SUBJECT: FORWARDS AMEND 3 TO FSAR. *co w/ Vol. 21 FSAR*

Subject: WPPSS NUCLEAR PROJECT NO. 2  
FSAR  
AMENDMENT NO. 3

The Washington Public Power Supply System herewith submits sixty (60) copies of Amendment No. 3 to its Final Safety Analysis Report. Amendment 3 incorporates NRC questions up through the Acceptance Review into the FSAR plus other minor changes.

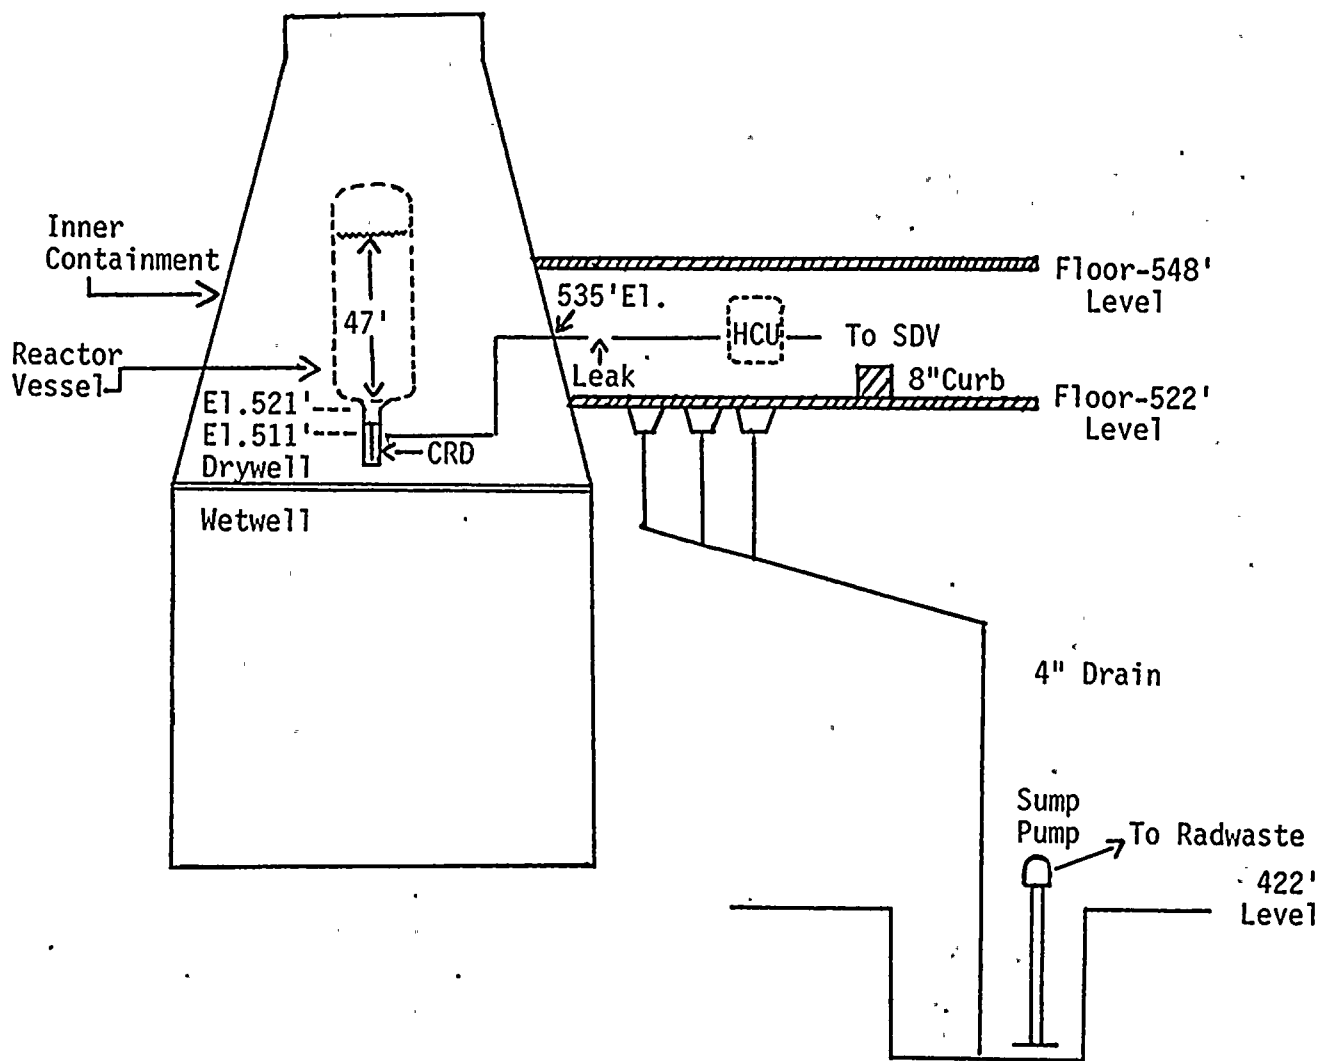
- I. A simplified diagram of the postulated line rupture is shown in Figure 010.066-1. It is assumed that a complete severance of a withdrawal line occurs, following a reactor scram, at a location between the reactor containment and the first isolation valve (in HCU). There is no back-flow through the break due to a check valve between the break location and the scram discharge volume (SDV). Therefore, the only leak out of the break is the reactor coolant that can leak around the CRD piston seals. This leakage is normally about 2 gpm and can be as high as 6 gpm with badly worn seals. The stipulation in the Question 010.066 above that no credit for seals be taken is an unrealistic conservatism. However, GE tests show that with seals completely missing, at operating pressure,

1. a. Type of fluid: Water
- b. Temperature: } See Figure 010.066-2
- c. Pressure: }
- d. Source of fluid: Reactor vessel
- e. Flow rate: See Figure 010.066-3
- f. Pipe internal diameter: }
- g. Wetted perimeter: }
- h. Total pipe internal volume: } Not applicable,  
see Item 1.j below.
- i. Exit flow area: }
- j. Area of flow restriction:  $1.19 \times 10^{-4} \text{ ft}^2$  -  
equivalent area for  
10 gpm leak at 1000  
psia.
- k. Differential elevation: See Figure 010.066-1
- l. Total flow resistance: Total pipe resistance was  
neglected for the low  
flow rates encountered.  
The hydrostatic analysis  
accounted for orifice  
pressure drop at the CRD,  
see Item 3.a below.

II. As stated in Part I.2 above, no equipment necessary for safe shutdown following scram is located in this area, therefore, environmental qualification is not an issue. The Supply System interprets ". . . no pump cavitation . . ." to refer to the sump pump to which the reactor leakage drains (see Figure 010.066-1). If the total leakage (assuming no flashing) drains to the sump, its water level would be 0.2". Therefore, pump cavitation is not an issue as the sump pumps are not required to prevent flooding.

- III. After 3.8 hours the leak is reduced to  $\leq 1.7$  gpm and 200°F water from the severed withdrawal line. It should be noted that a leak of 1.7 gpm is possible only by neglecting all withdrawal line losses and assuming no CRD piston seals exist. The realistic flow rate would be much less. A temporary fix could be effected easily by plugging or freeze sealing the tube. Since a permanent fix becomes a question of availability and the total scenario given in Part I indicates no safety questions pertain to the incident, the Supply System does not feel a commitment to maintain and verify the existence of the equipment necessary to fix a leak of less than 1.7 gpm is prudent or necessary.

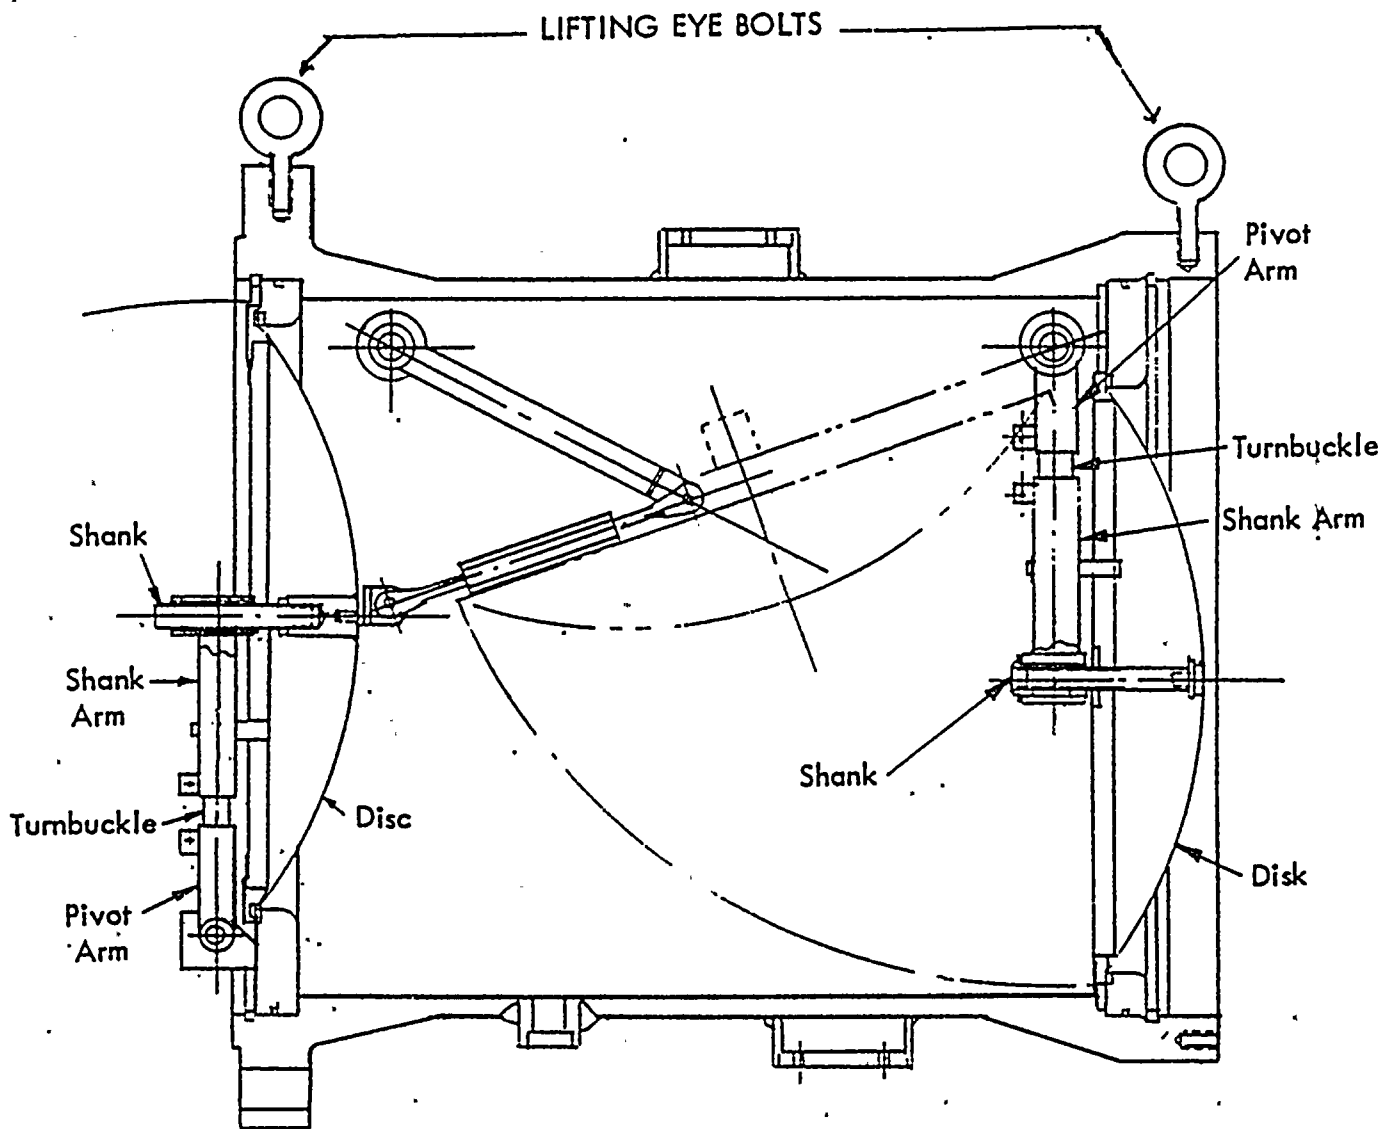
- c. The attached Figures (2-1 and 2-2) from the manufacturer's instruction manual illustrate the configuration of the double disk vacuum breaker assembly, and the seal detail. FSAR Reference 3.8-8, which was provided to the NRC, also provides illustrations and details of the vacuum breaker system and the Anderson, Greenwood & Co. vacuum breaker valves.

The minimum flow area of the vacuum breaker valves is 295.6 square inches based on the 19.4 inch diameter inlet orifice. Capacity certification tests were performed on 3 wetwell-drywell and 3 reactor building-wetwell vacuum breaker valves. Using the flow data from these tests, resistance coefficients (K) were determined as follows:

MEASUREMENTS FOR STRAINERS AT  
PENETRATIONS X-32, X-35, X-36  
RATED FLOW: 8,400 gal/min

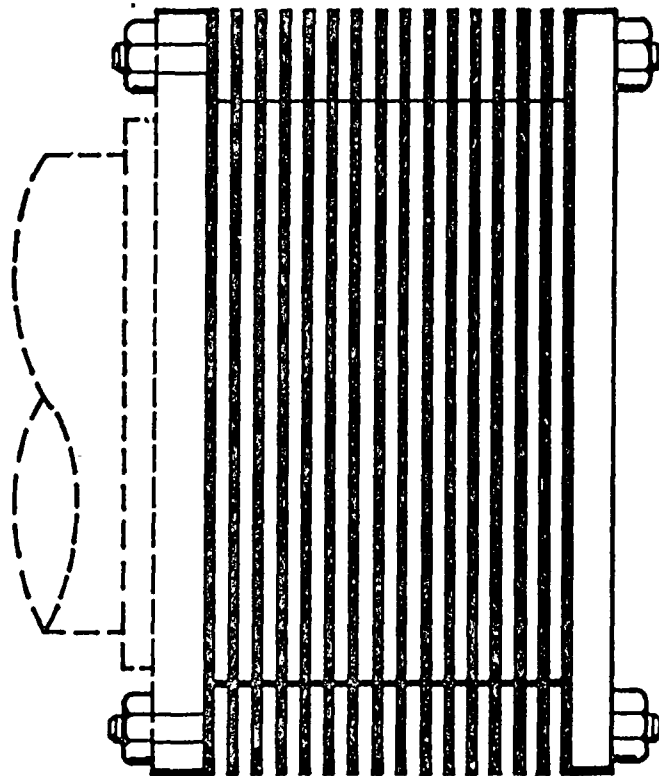
The strainers are cylindrical, as shown on Figure 022.039-1. Strainer hole diameter is 0.09375 inch. Strainers are attached to ANSI 150# RF Flanges.

The drawing of a typical strainer is provided in Figure 022.039-1.

FIGURE Q 022.061-1

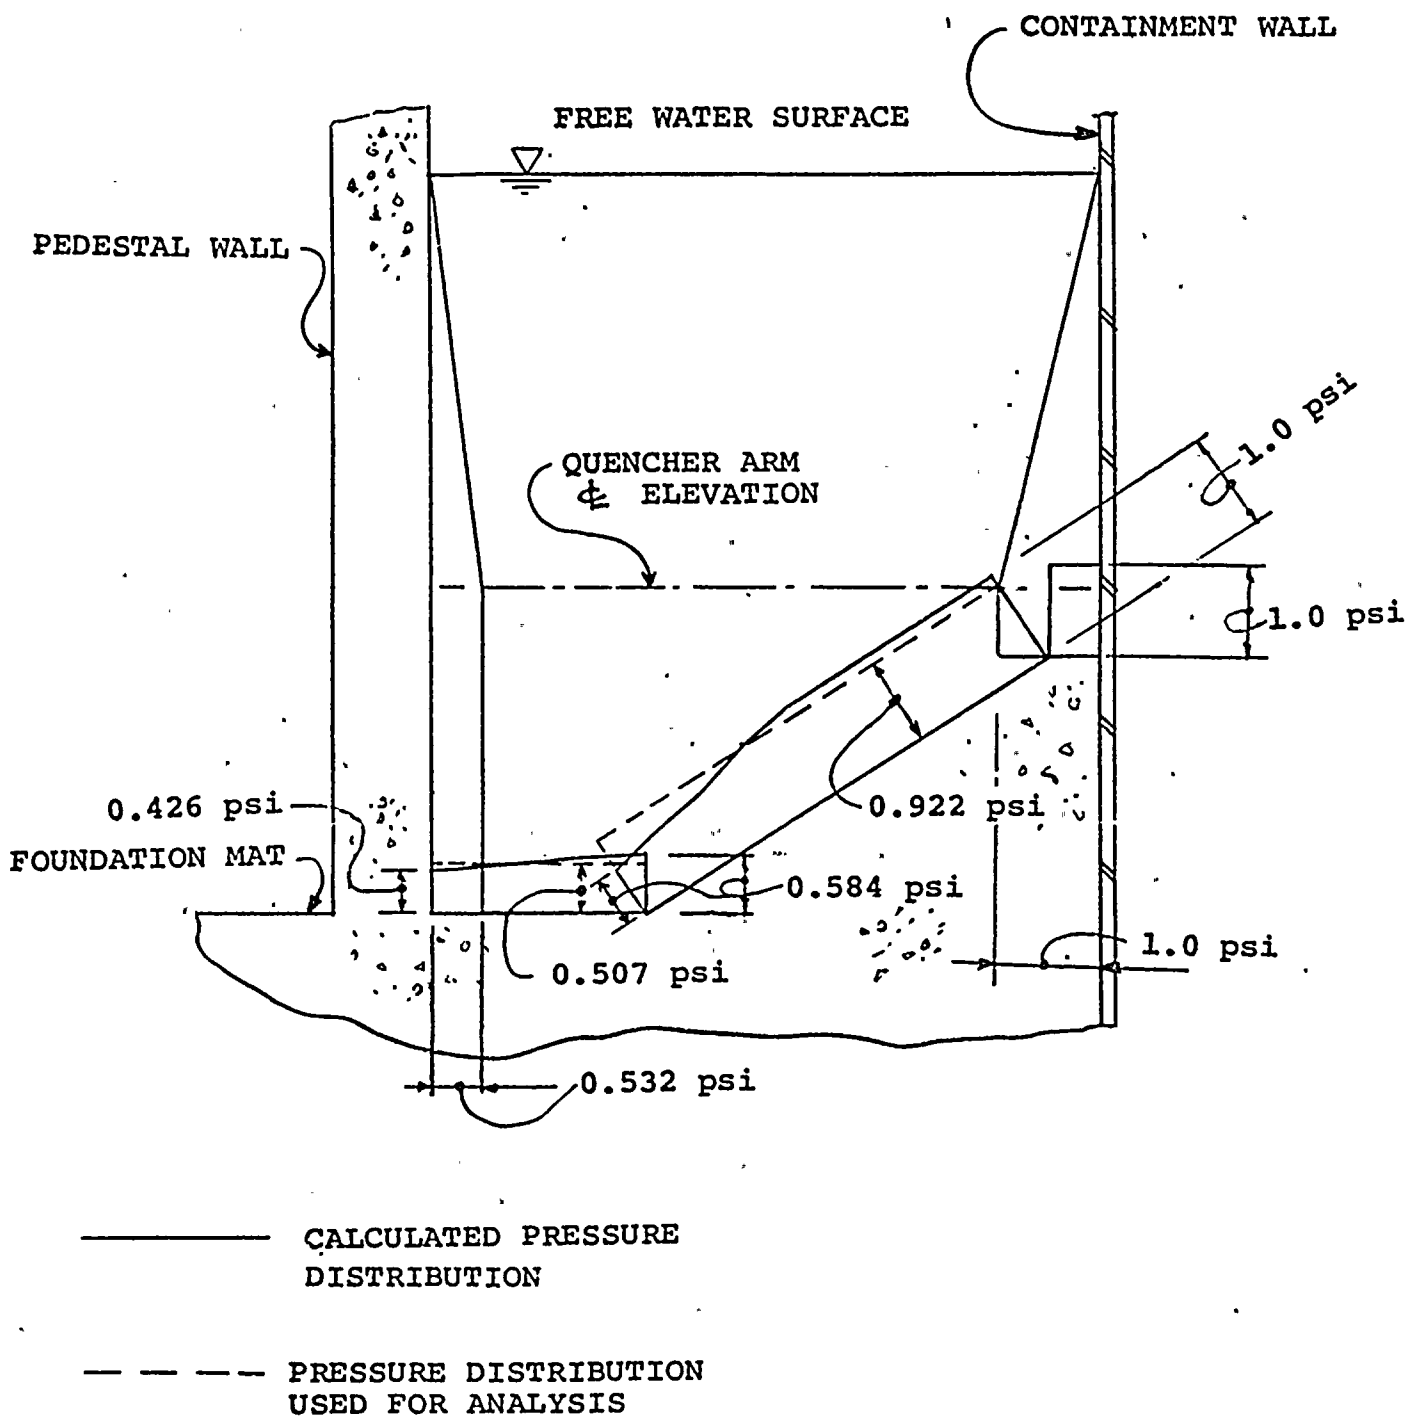
Figures 022.061-1 and 022.061-2 illustrate the pressure distributions along the suppression pool floor and on the pedestal and containment walls for two SRV discharge cases, the all-valves case and single outer valve case. These two cases were determined to be the governing cases for the WNP-2 plant design, although the plant was also assessed for a single inner valve discharge case, a two valve discharge case and for the ADS case.

FIGURE Q 022.061-3

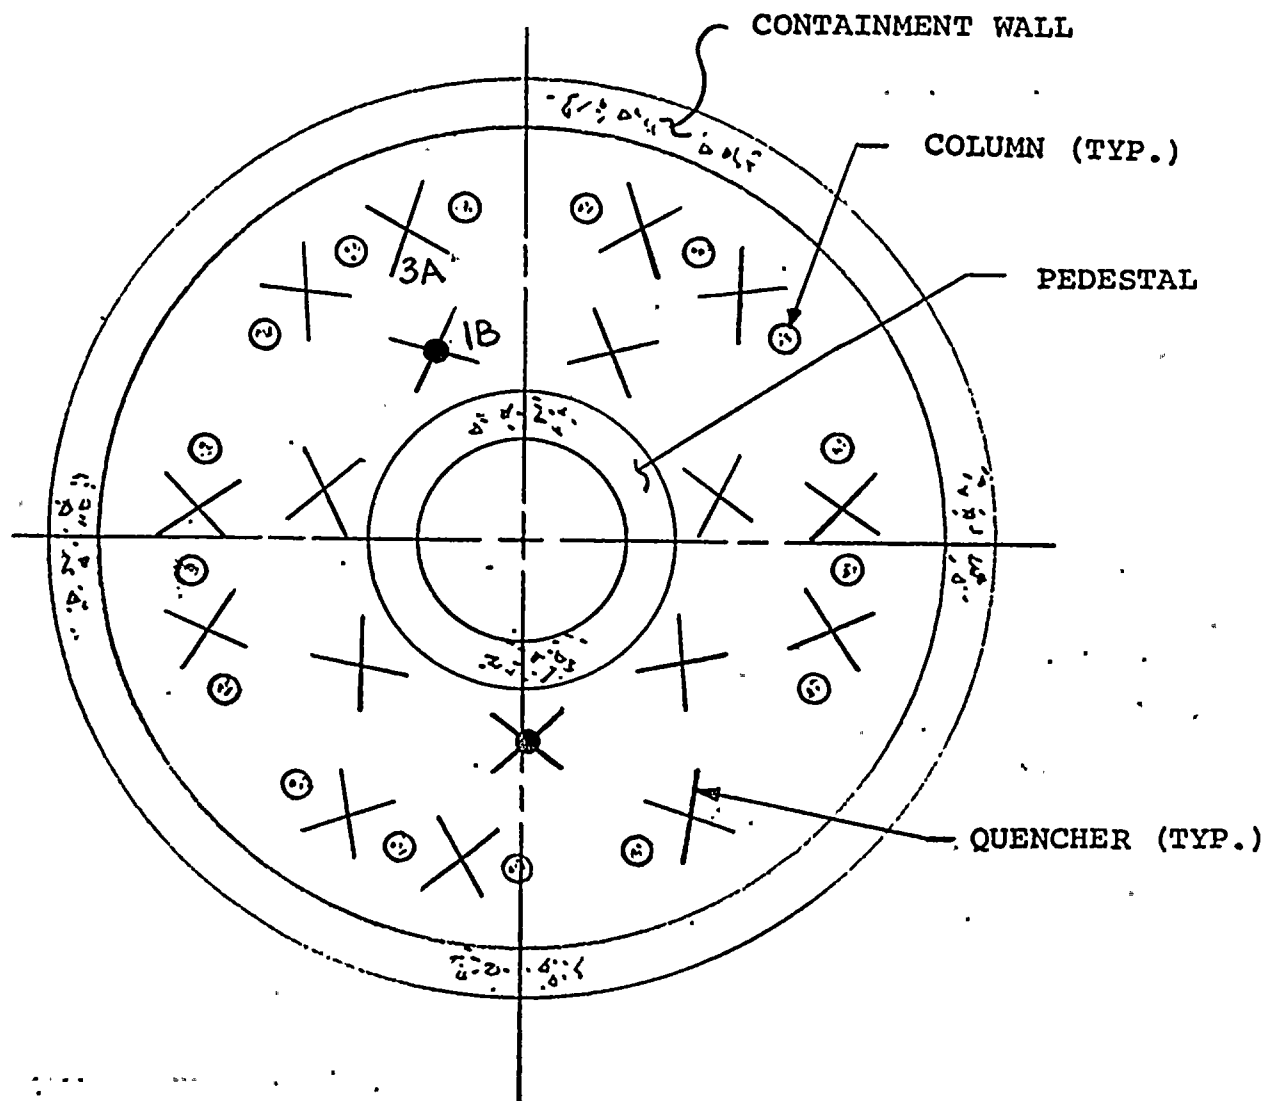
Figure 022.061-3 illustrates the circumferential distribution of pressure loading for the single outer valve case. It should be noted that there is no pressure variation in the circumferential direction for the all valves discharge case.

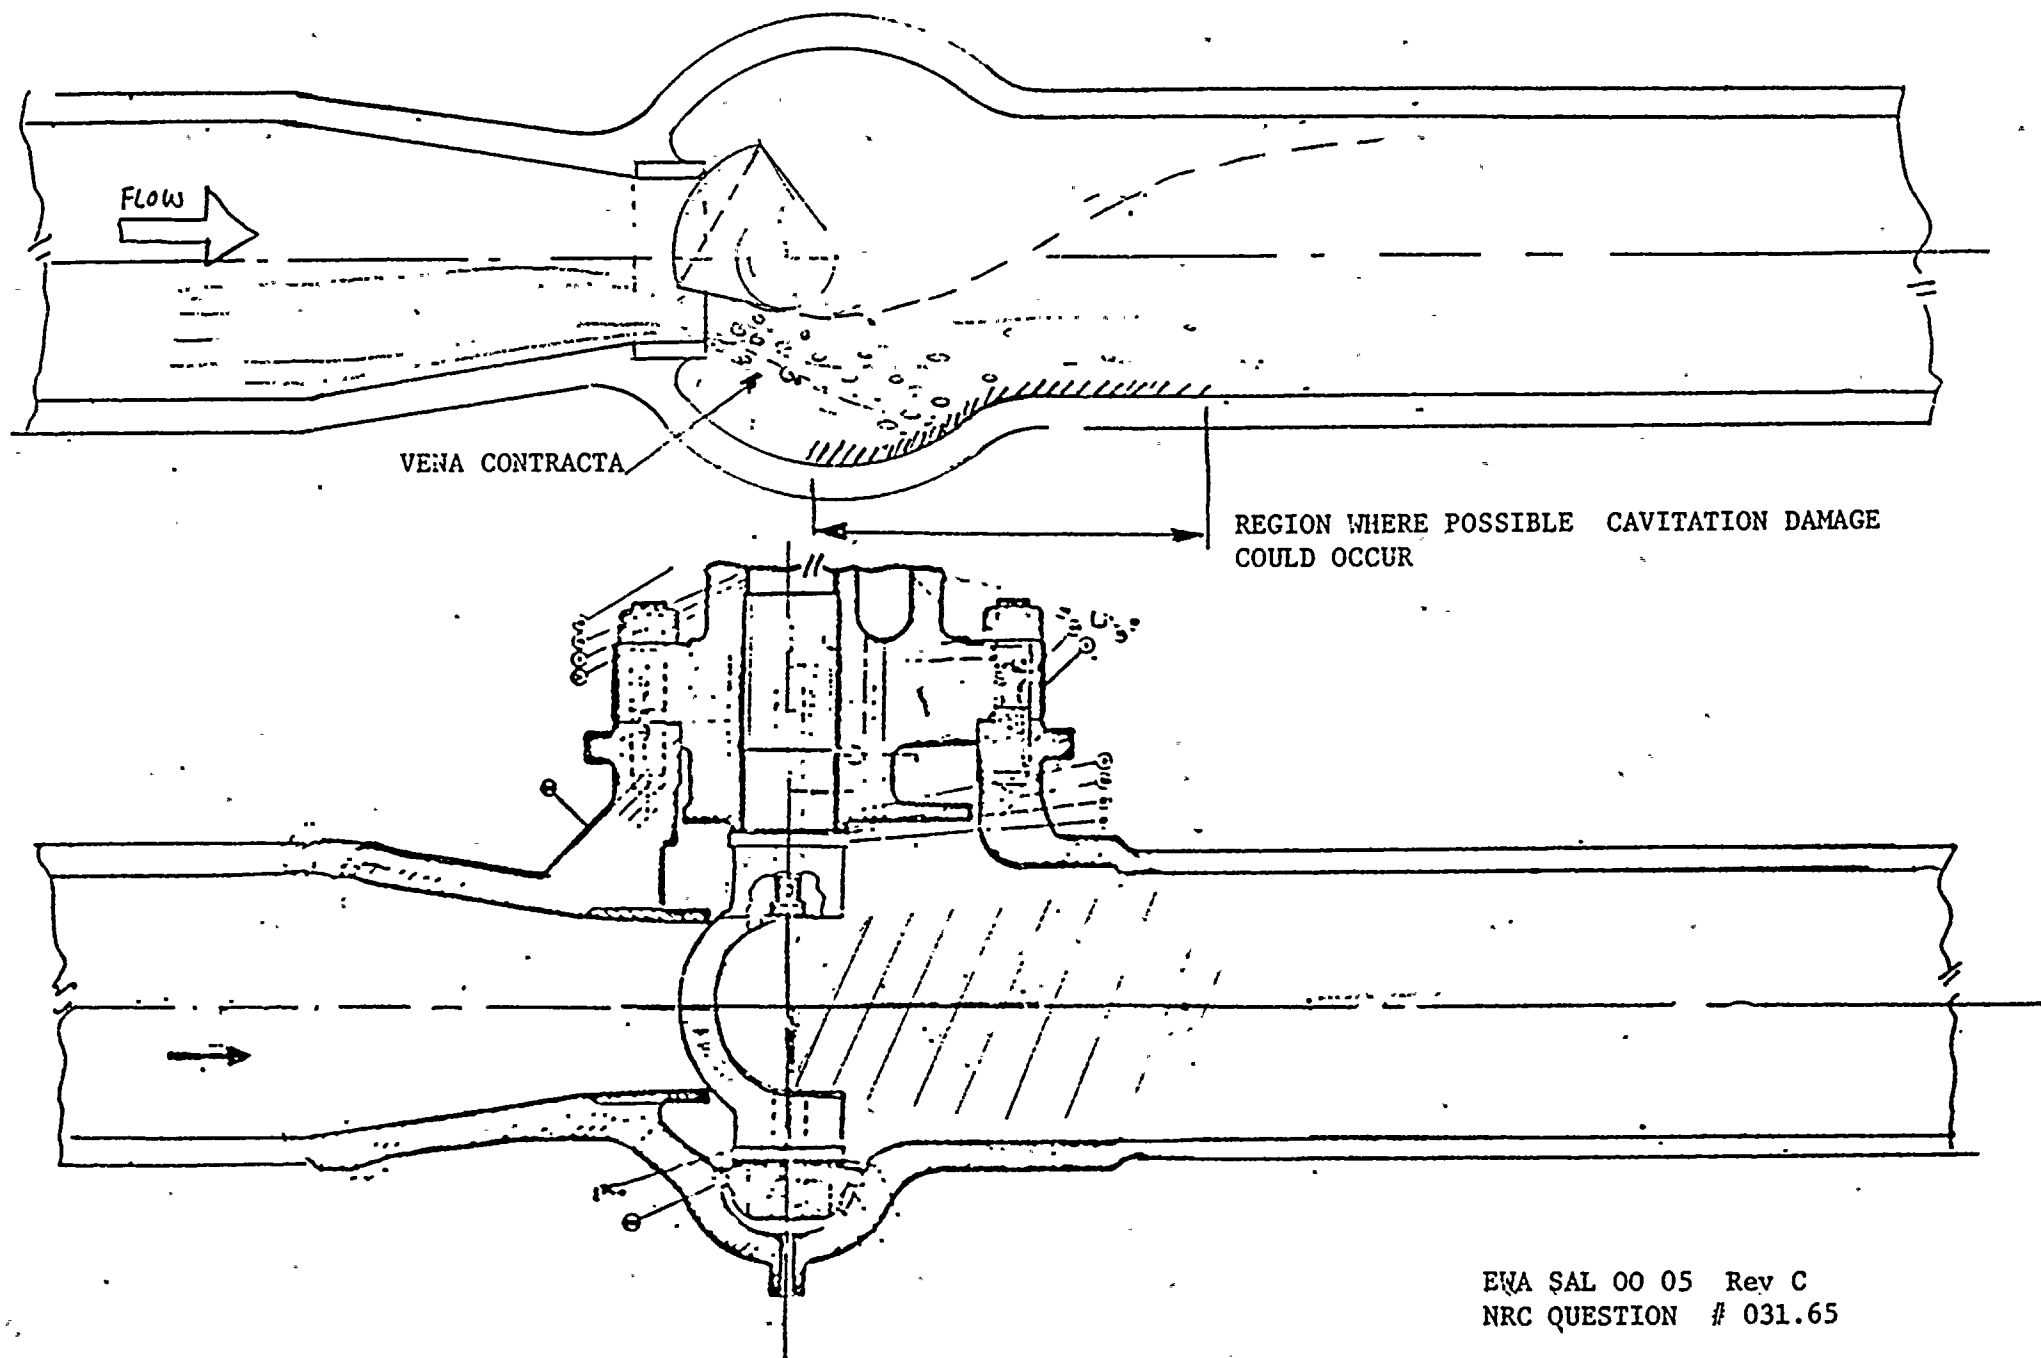
Your response to Item 31.010 is incomplete. Identify the specific recirculation flow control valve components which would be damaged by the collapse of bubbles in the pressure recovery areas of these valves.

In response to 31.065, enclosed is a figure which describes where possible cavitation damage could occur by the collapse of bubbles in the pressure recovery areas of the flow control valves.

Full cavitation, however, is a very unlikely event in the FCV. In addition, even if full cavitation occurs in the FCV, it would take 4 to 8 hours before the 0.003 in. corrosion allowance is worn away locally.
